SERVICE BULLETIN

Service Bulletin No.: DA20-77-02 Rev 2

Title: Electric Tachometer

FIGURE 1

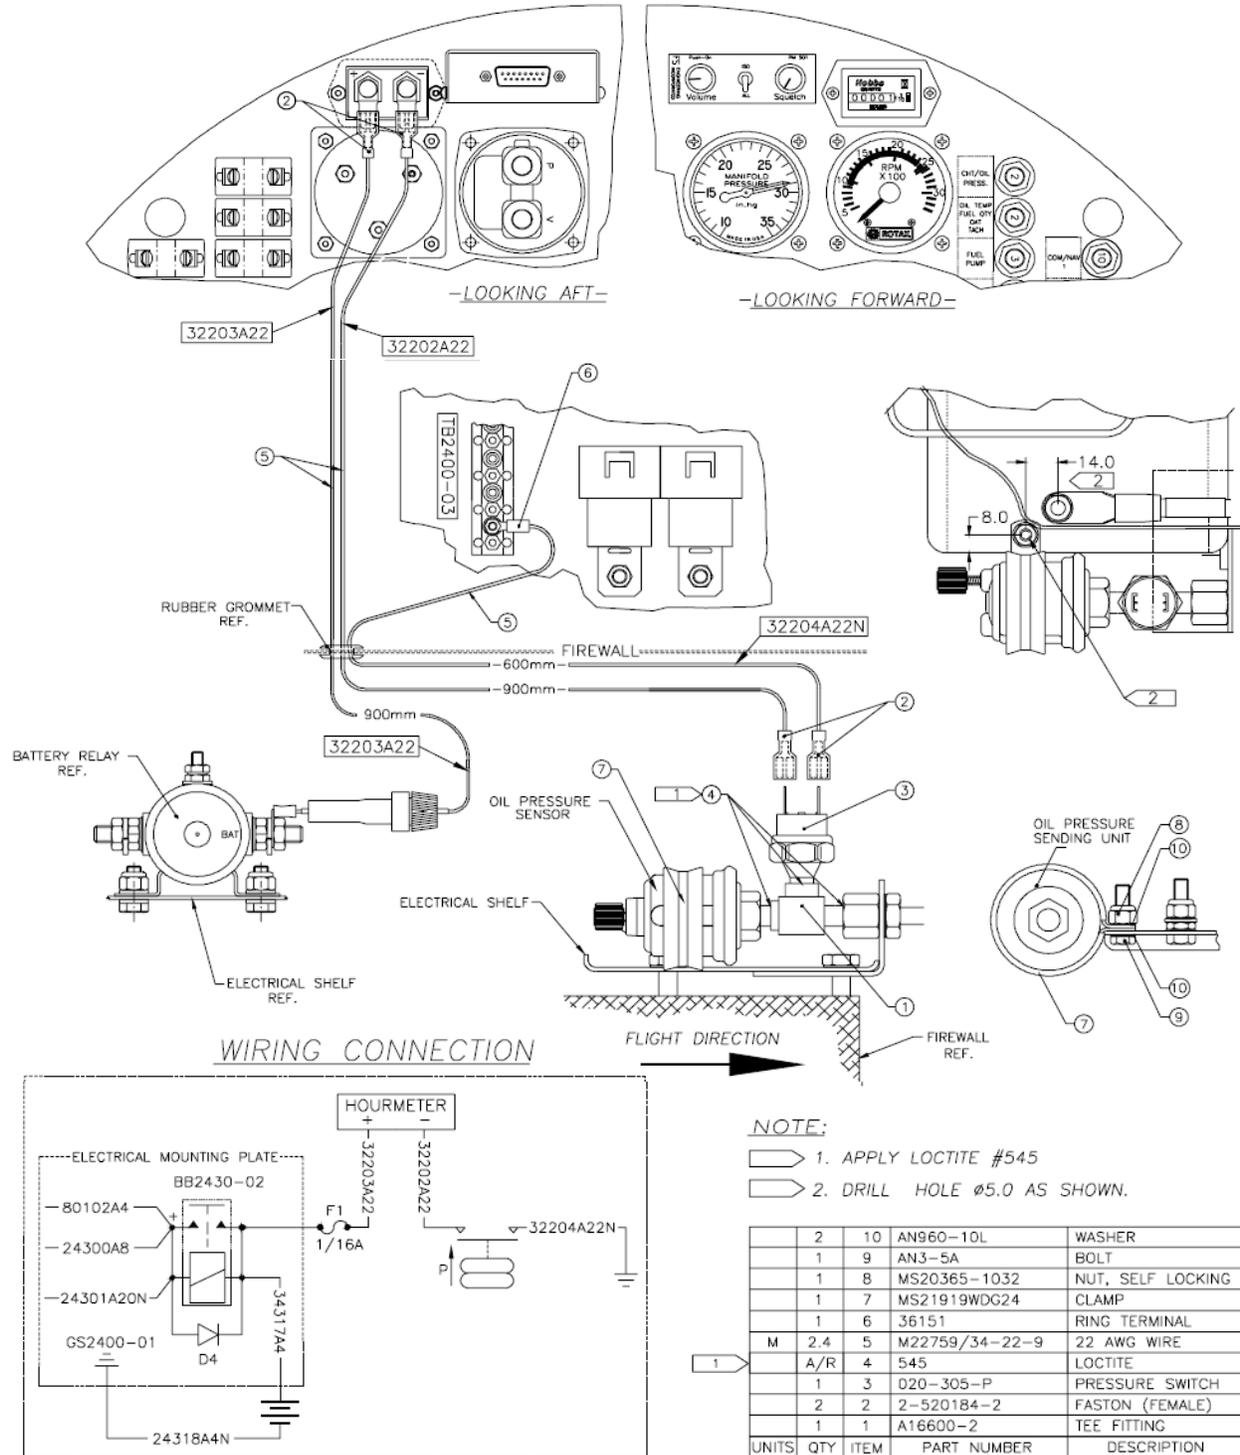
- 10.22 Refer to figure 1, note 2. Locate and drill a 3/16" (5.0mm) hole in the electrical shelf.
- 10.23 Apply Loctite 545 to the male thread on the tee fitting and connect to the bulkhead fitting.

- 10.30 Connect wire # 32202A22 to the (-) terminal of the hour meter.
- 10.31 Connect wire # 32204A22N to TB2400-03 as shown in figure 1.
- 10.32 Attach wire # 77207A22 to the load side of the circuit breaker marked 'Tach.' and attach the other end to the (+) terminal of the new tachometer.

- 10.36 Route wire # 77209A22 through the firewall to the engine trigger coil connector shown in figure 1. Install the pin on the white wire to pin 1 of the supplied connector. Install the pin with the blue wire into pin 2 of the supplied connector. Install the connector labels, refer to the wiring schematic in figure 2.

FIGURE 2

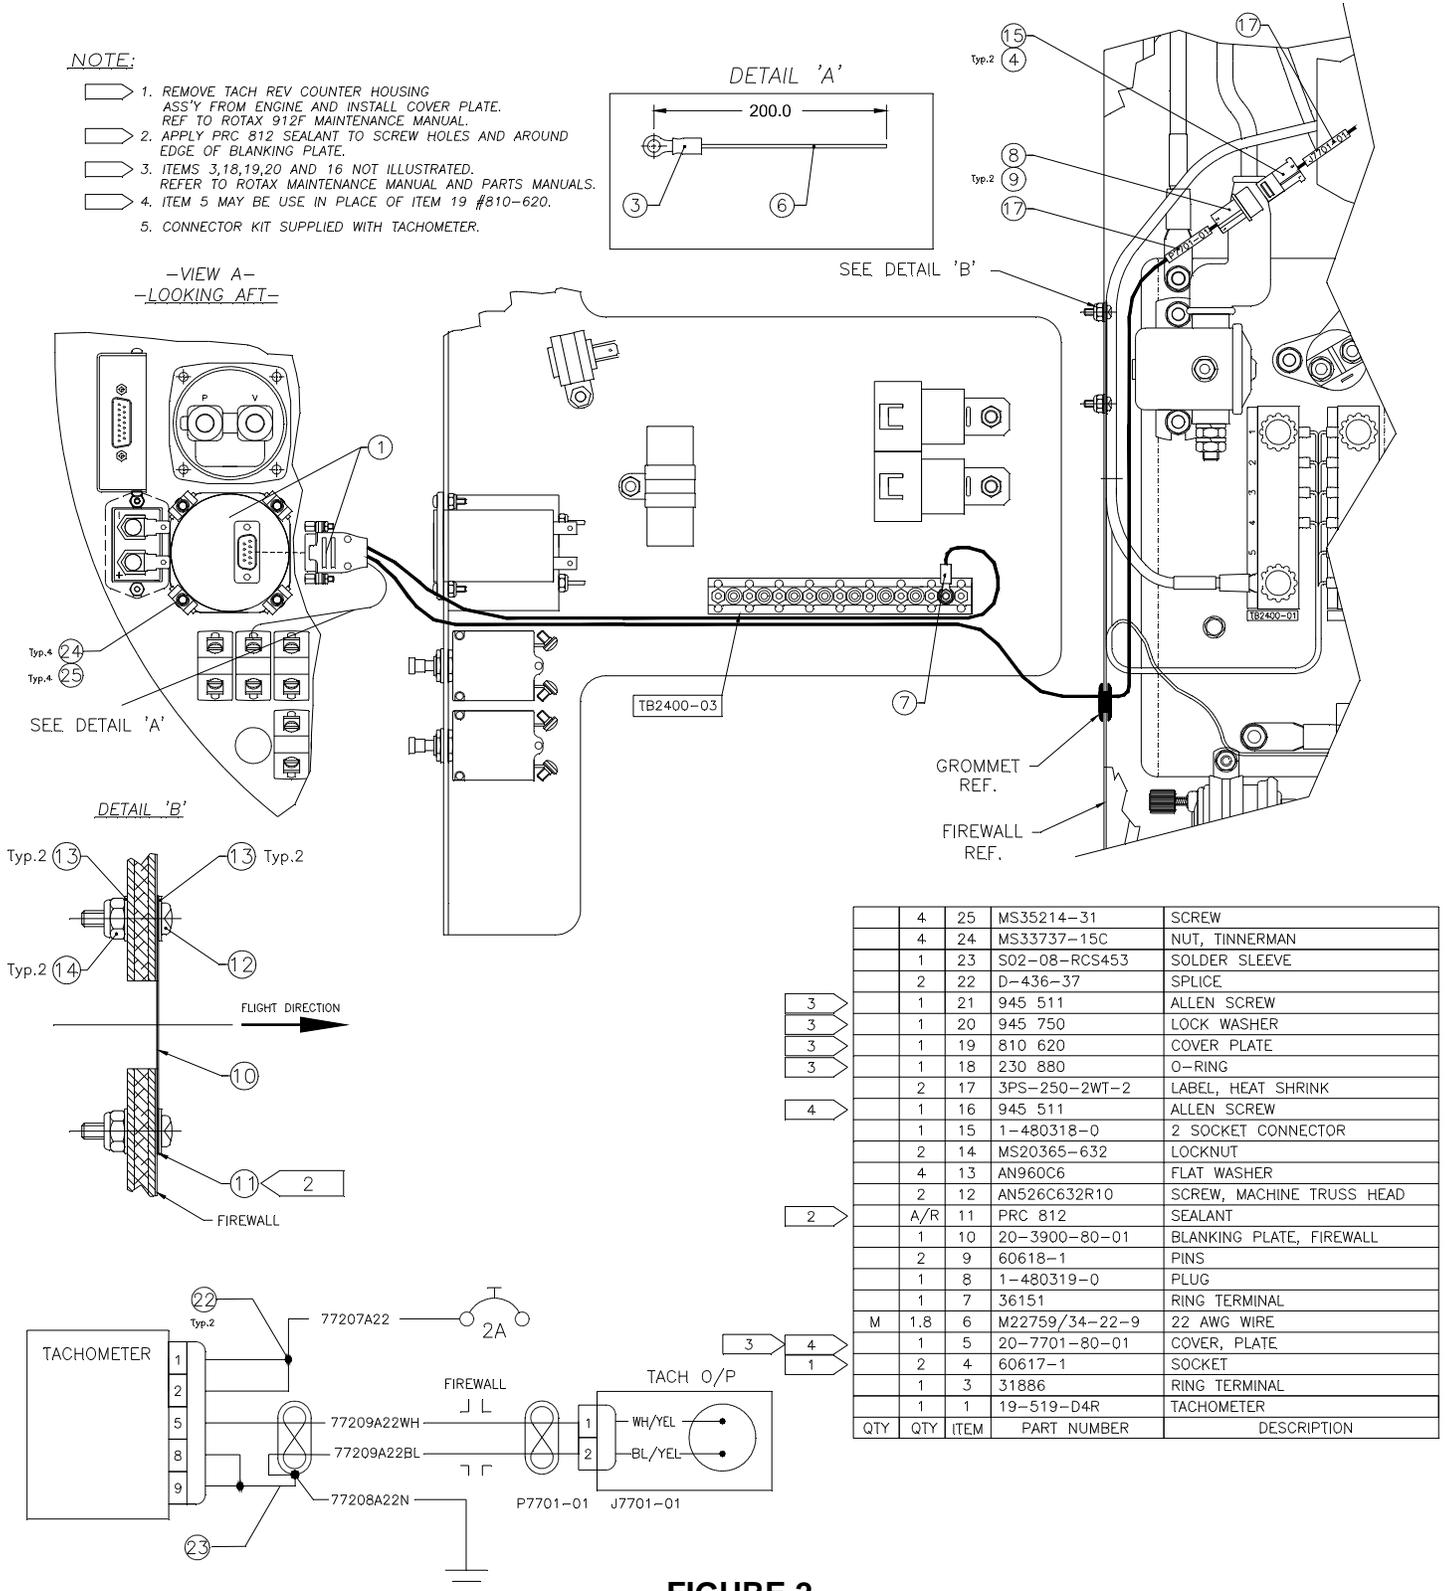
1. REMOVE TACH REV COUNTER HOUSING ASS'Y FROM ENGINE AND INSTALL COVER PLATE. REF TO ROTAX 912F MAINTENANCE MANUAL.
2. APPLY PRC 812 SEALANT TO SCREW HOLES AND AROUND EDGE OF BLANKING PLATE.
3. ITEMS 3,18,19,20 AND 16 NOT ILLUSTRATED. REFER TO ROTAX MAINTENANCE MANUAL AND PARTS MANUALS.
4. ITEM 5 MAY BE USE IN PLACE OF ITEM 19 #810-620.
5. CONNECTOR KIT SUPPLIED WITH TACHOMETER.

- 10.35 Route wire # 77209A22 and 77208A22N along the existing wire route toward the firewall. Connect wire # 77208A22N to terminal block TB 2400-03 and connect to the location shown in figure 2.
